SUNDRY NOTICES AND REPORTS ON WELLS (DO NOT USE THIS FORM FOR PROPOSALS TO DRILL OR TO DEEPEN OR PLUG BACK TO A DIFFERENT RESERVOIR. USE "APPLICATION FOR PERMIT" (FORM C-101) FOR SUCH PROPOSALS.)		WELL API NO. 30-015-36753

2. Name of Operator Mewbourne Oil Company		6. State Oil & Gas Lease No.
3. Address of Operator PO Box 5270, Hobbs NM 88241		7. Lease Name or Unit Agreement Name Quick Draw 15 H

COMPLETION PROCEDURE

CONDITIONS OF APPROVAL FOR PLUGGING & ABANDONMENT

Quick Draw 15H #1
Last Updated: 11/20/2014
By: J. Nave

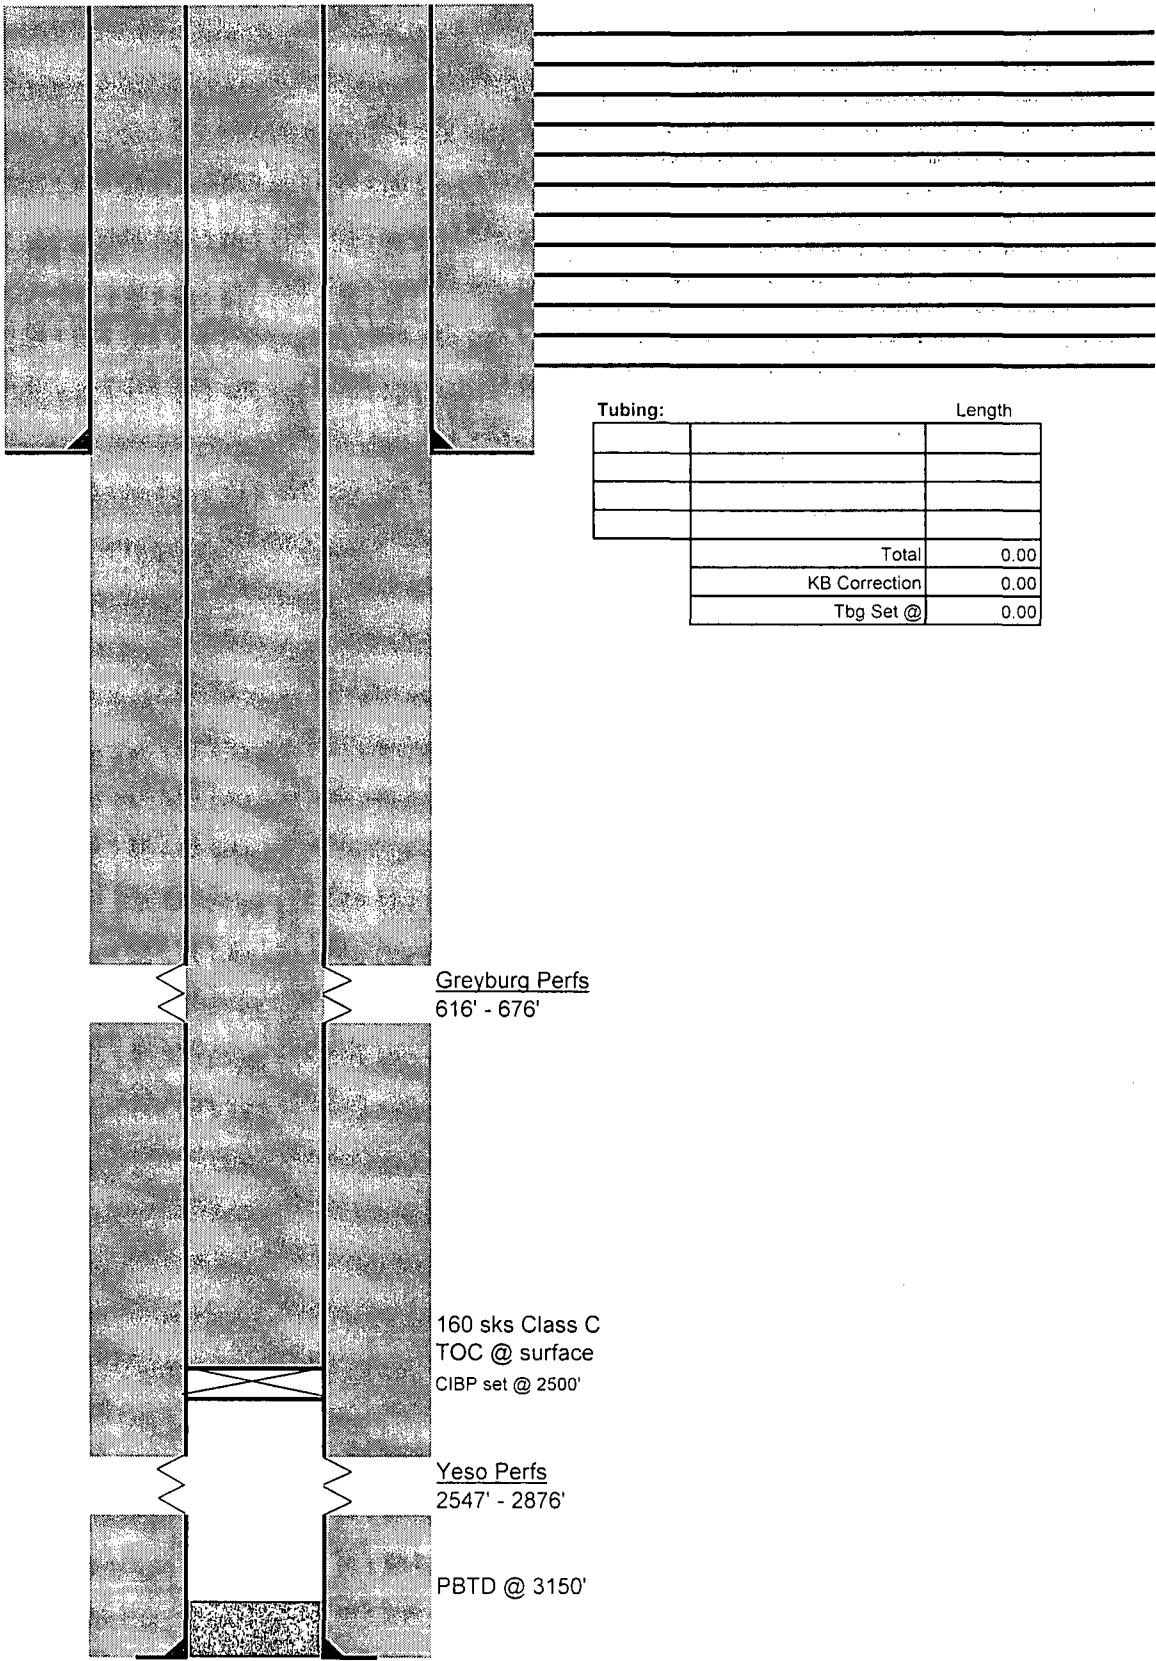
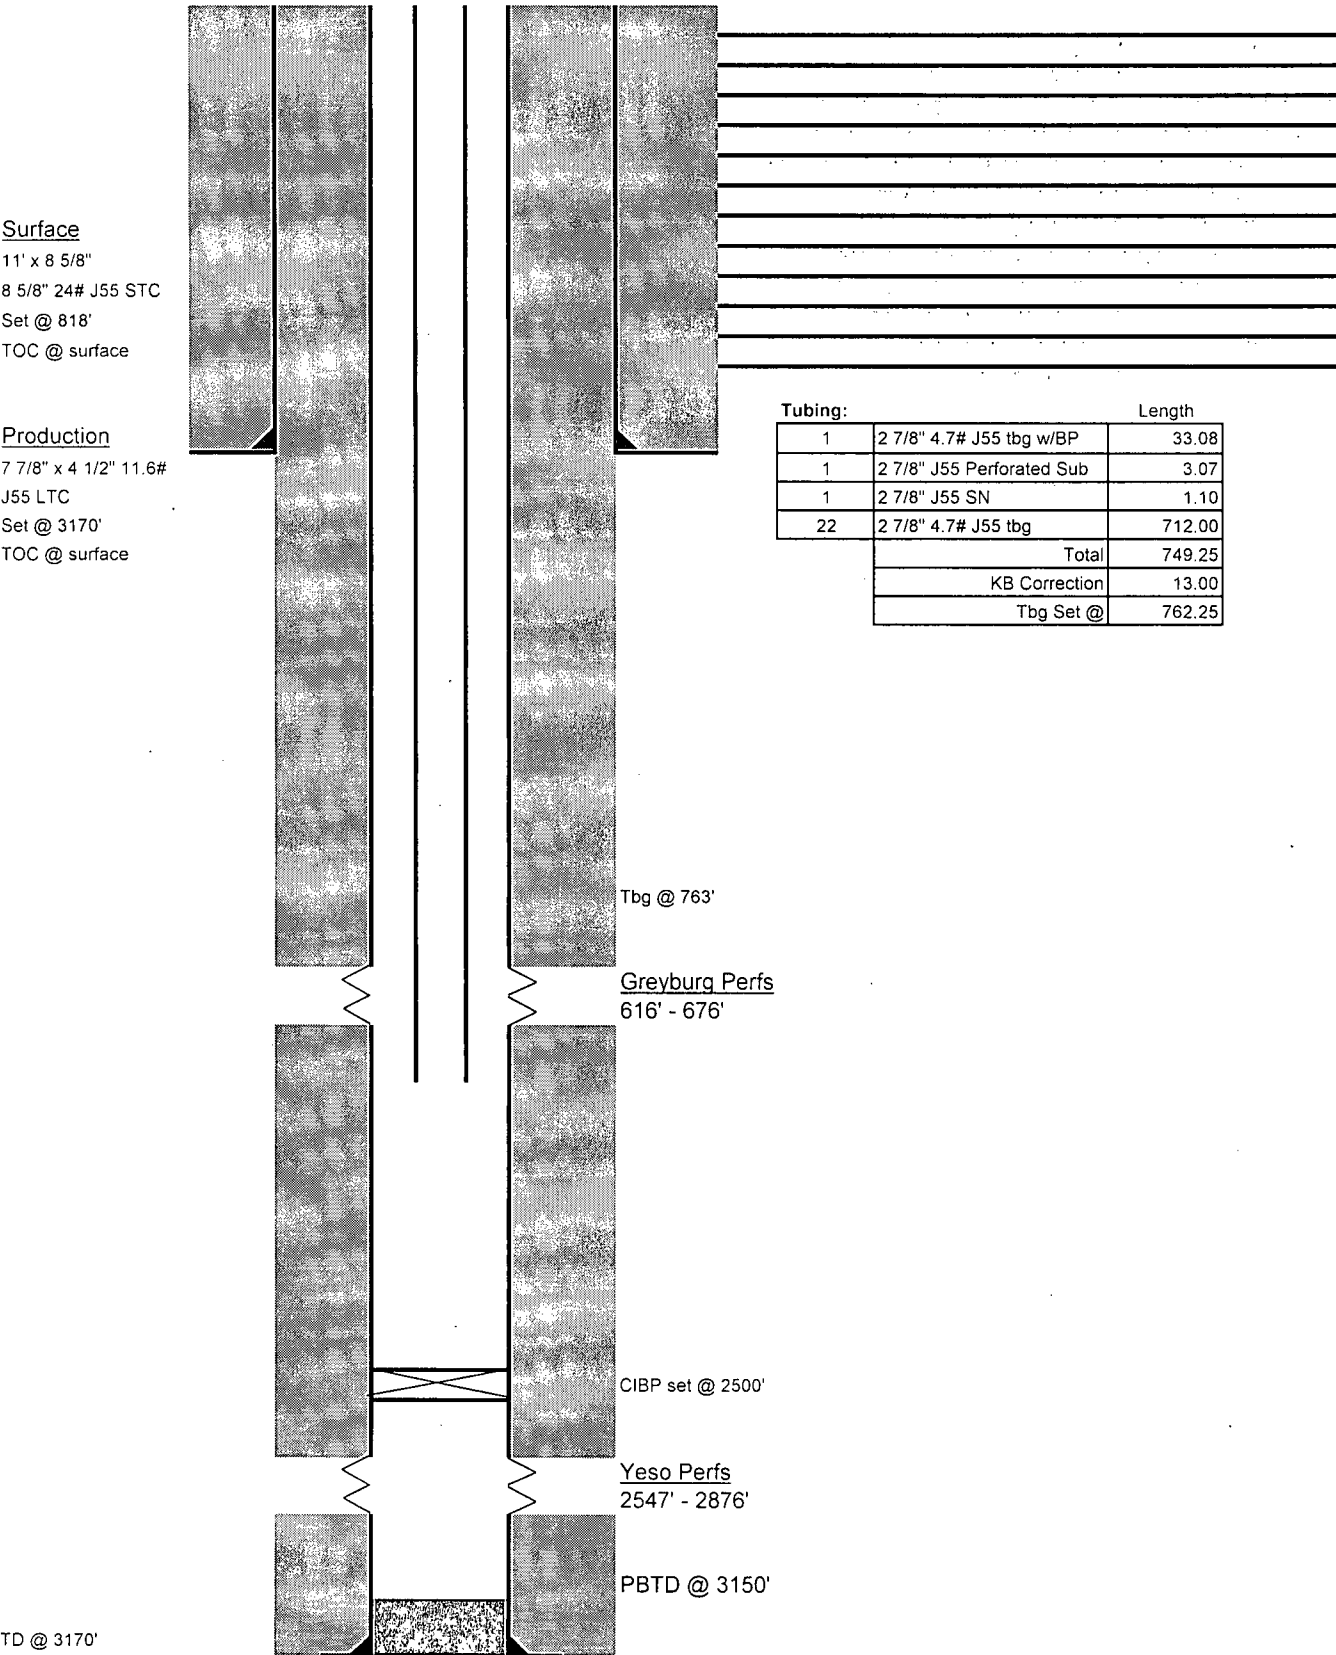
Please review the attached plugging procedure for the above captioned well.

1. Test anchors.
2. MIRU BCM. ND wellhead & NU BOP. POOH w/tbg & LD perforated sub.
3. RIH w/tbg to CIBP @ 2500'.
4. Pump 160 sks Class C to surface.
5. POOH w/tbg and WOC.
6. If cmt circ top off from surface. If did not circ tag and pump 2nd plug.
7. RDMO BCM.
8. Cutt off Wh & install dry hole marker @ ground level.

Approved for plugging of well bore only.
Liability under bond is retained pending receipt
of C-103 (Subsequent Report of Well Plugging)
which may be found at OCD Web Page under
Forms, www.cmnr.state.nm.us/oed.

Approval Granted providing work is

Completed by 3-24-2016

* See Attached COA's
